SERVICE BULLETIN

M-963 - Replaces M-956

ALIGNMENT - C.V. CARBURETOR MANIFOLD AND FLANGES

Figure 1. Alignment - XLH Manifold and Flange(s)

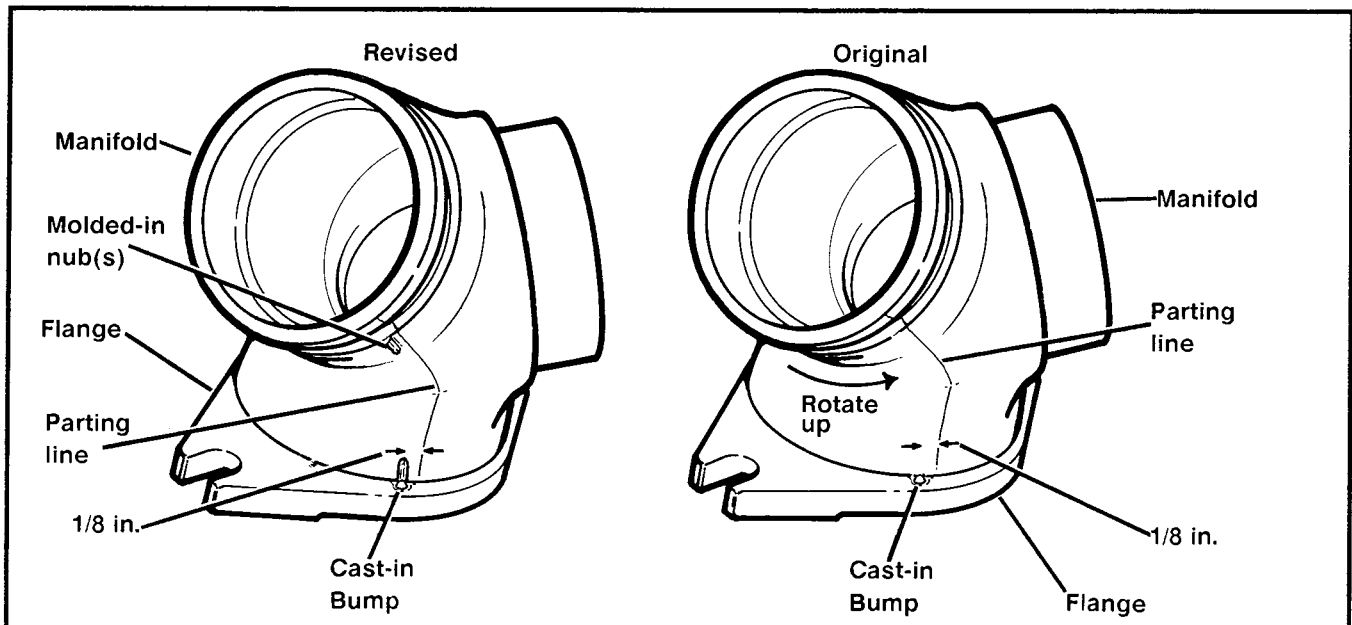
The manifold alignment marks have been changed since Service Bulletin M-956.

See figure 1. The hard rubber manifold now has molded-in nubs 1/8 in. off the bottom parting line.

Both flanges have a small cast-in bump.

- There are now two types of C.V. carburetor manifolds on XLH vehicles:
Manifold with molded-in nubs (late 1988 - current production).
Manifold without molded-in nubs (early 1988 - previous production).
- The **cast-in bumps** on the flanges have been designed to align with the **molded-in nubs** on the manifold.
- On XLH vehicle manifolds without nubs, align so the flange bumps are 1/8 in. **PAST** the parting line on the manifold.

Align the flange bumps with the manifold nubs when installing current production XLH carburetors.

- Place the manifold and flange assembly in position on the cylinder head studs.
- On late 1988 XLH vehicles, align the bumps on the flanges with the nubs on the manifold.
On early 1988 XLH vehicles that have manifolds without the nubs:
 - Align the flange bumps and manifold parting line.
 - Rotate the manifold **up** until the parting line is 1/8 in. **PAST** the bumps.
- Install the stud washers and nuts. Install the cylinder head washers and socket head bolts.
- Check to be sure the manifold and the flanges are still aligned.

DO NOT tighten the nuts and bolts and then try to align the manifold and flange bumps. The manifold will be damaged.

- Tighten the flange stud nuts and socket head bolts to 6 - 10 ft-lbs torque.
- Check to be sure the manifold and the flanges are still aligned.
- Install the carburetor as described in the 1986 to 1988 XLH Models Service Manual.
